<b>Product/Process Change Notice (PCN)</b>	
<input checked="" type="checkbox"/> Major Change <input type="checkbox"/> Minor Change	
<b>PCN Number:</b> PCN_UtSTST_20250319  <b>Affected Series:</b> WE-STST  <b>Affected Part Number:</b> 74930000, 74930100  <b>PCN Date:</b> 2024-12-19 (YYYY-MM-DD) <b>Effective Date:</b> 2025-03-19 (YYYY-MM-DD)	<b>Change Category:</b> <input type="checkbox"/> Equipment/Location <input type="checkbox"/> General Data <input type="checkbox"/> Material <input type="checkbox"/> Process <input checked="" type="checkbox"/> Product Design <input type="checkbox"/> Shipping/Packaging <input type="checkbox"/> Supplier <input type="checkbox"/> Software
<b>Contact:</b> Product Management <b>Phone:</b> +49 (0) 7942 - 945 5001 <b>Fax:</b> +49 (0) 7942 - 945 5179 <b>E-Mail:</b> pcn.eisos@we-online.com	<b>Datasheet Change:</b> <input type="checkbox"/> Yes <input checked="" type="checkbox"/> No  <b>Attachment:</b> <input type="checkbox"/> Yes <input checked="" type="checkbox"/> No

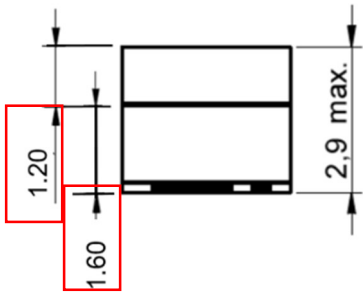
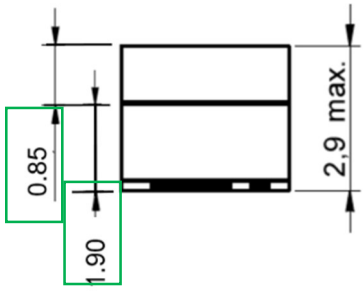
<b>DESCRIPTION OF CHANGE:</b> To improve the processability, Würth Elektronik eiSos will change the core sizes of these products.  There will be no change in fit, function, quality or reliability of the product.  The new revision of the affected order codes will be sent out after the previous revision is out of stock (according to FIFO - first-in, first-out).	
<b>DETAILS OF CHANGE:</b> <ul style="list-style-type: none"> <li><b>Core dimensions:</b> change core height of top core from 1.20 mm to 0.85 mm, and bottom core from 1.60 mm to 1.90 mm.</li> </ul>	
<b>Before Change</b>	<b>After Change</b>
